9.4 Air Conditioning, Heating, Cooling and Ventilating Systems

The information in this section of the reference ABWR DCD, including all subsections, tables, and figures is incorporated by reference with the following departures and supplements.

Figure 9.4-2c Electrical Building HVAC System Diagram
Turbine Building Electrical Equipment Areas (EEA) HVAC System Diagram

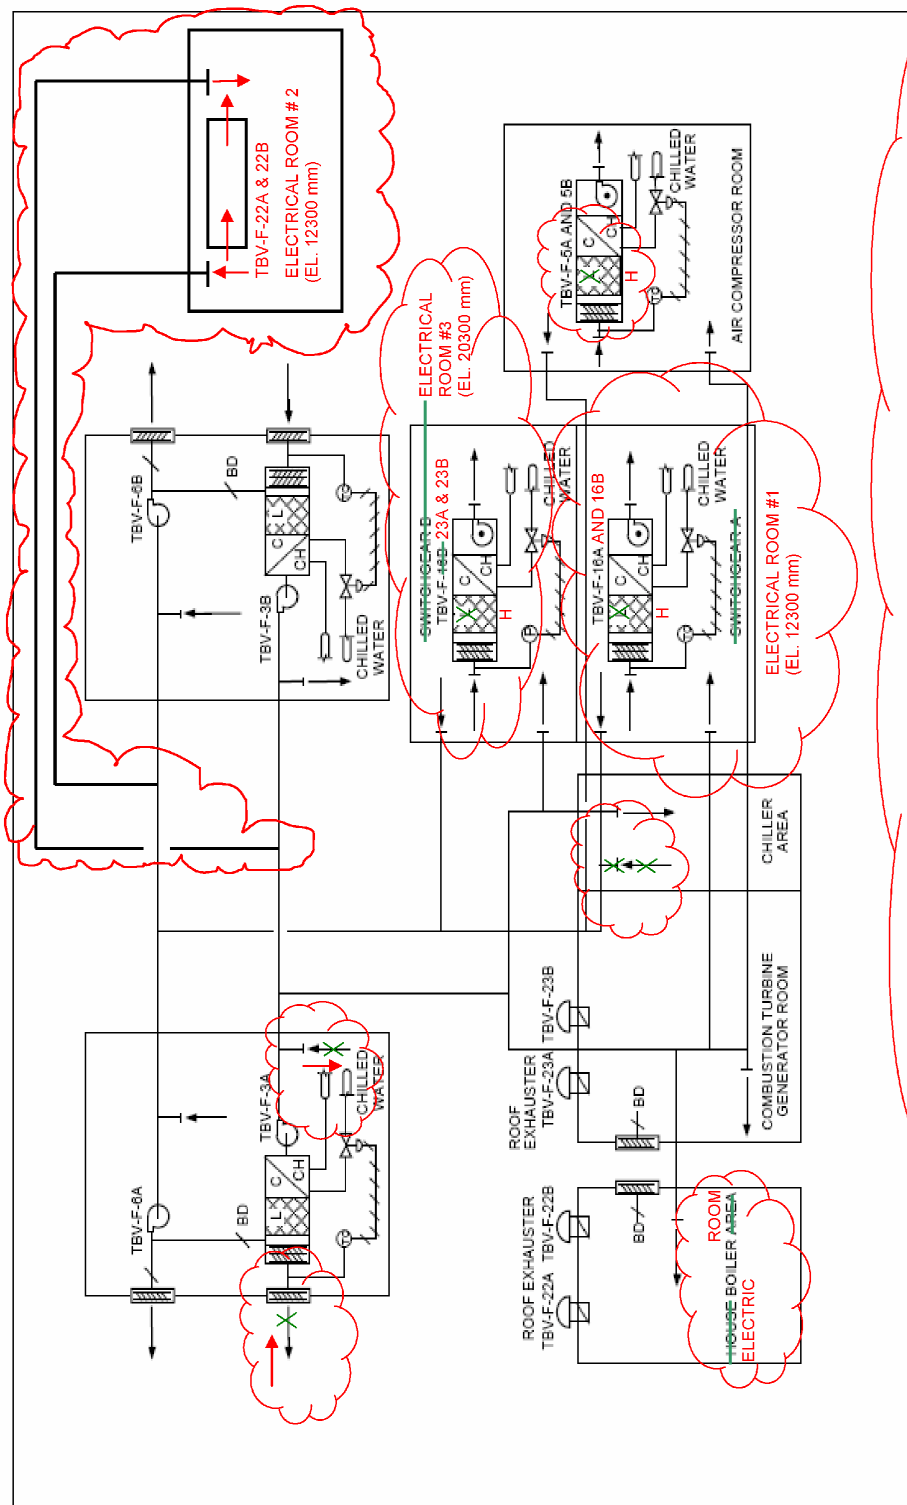
STD DEP 9.4-4 (Tables 9.4-3, 9.4-5, 9.4-5a, 9.4-5b, 9.4-5c, and 9.4-5d), (Figures 9.4-2a, 9.4-2b Sheet 2, and 9.4-2c)

The Turbine Island heating, ventilating, and air conditioning system consists of the Turbine Building (T/B) HVAC System and the Turbine Building Electrical Building (E/B) Equipment Areas (EEA) HVAC System.

9.4.4.2.2 ~~E/B~~ EEA HVAC General Description

The ~~E/B~~ EEA HVAC schematic diagram is shown on Figure 9.4-2c.

9.4.4.2.2.1 Electrical ~~Building~~ Equipment Areas HVAC System

The Electrical ~~Building~~ Equipment area HVAC System is provided with two 100% capacity air supply fans and two 100% capacity exhaust fans.

The air supply fan draws outside air through louvers, control dampers, low efficiency filters, and chilled water coils, and discharges air directly into the ~~switchgear~~ electrical rooms, chiller, combustion turbine generator, house electric boiler room and air compressor rooms. Return air ~~Ductwork~~ ductwork and bypass dampers are is provided to allow recirculation of air from the ~~switchgear electrical rooms and chiller rooms~~ air compressor room.
